Cree® XLamp® XP-E2, XQ-E HD & XQ-E HI Green LED Product Change Notification

Customer Name: XP-E2, XQ-E HD & XQ-E HI PCN Reference Number: CREE-PCN-1240

Green LED customers Date Issued: December 18, 2020

XP-E2 Green

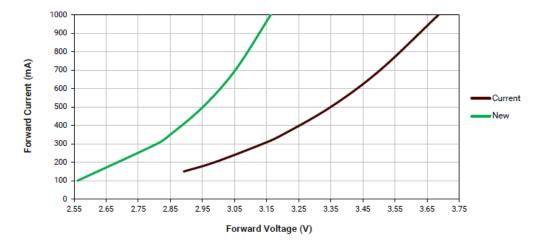
Cree will be increasing the typical luminous flux and changing the typical forward voltage, temperature coefficient of voltage, and thermal resistance characteristics for XP-E2, XQ-E HD, and XQ-E HI Green LEDs. Current order codes will begin to receive the new typical performance resulting in a brighter luminous flux distribution than previously delivered. Cree XLamp® XP-E2, XQ-E HD and XQ-E HI LED order codes specify only a minimum flux bin and not a maximum.

The following graphs show the improved Forward Voltage vs. Current curves.
